PERMIT CARD _____

SEPTIC TANK, LEVEL 1250 CLEANOUTS S.T. / D.W.

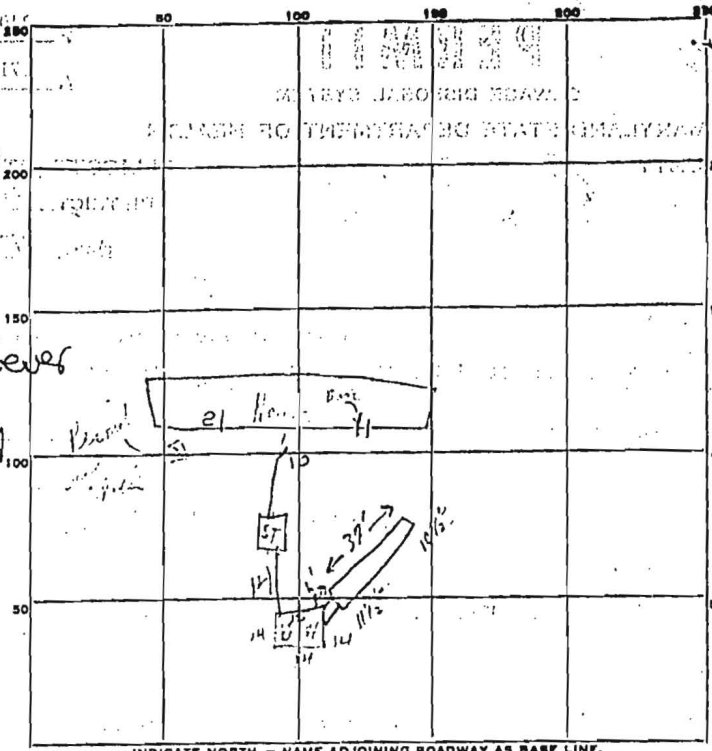
spoke to Mr. Schuster on 10/22/76

he will
have cap
loosen to
have DW
depth
checked
ok to
cover however
DW will
be checked

REMARKS 10/19/76 checked trench 37' long with depth
10/21 - unable to measure depth of clay well - placed paper
on all stone in D.W. then call for final
 DATE SYSTEM APPROVED 10/22/76 INSPECTOR W.A. BENSON
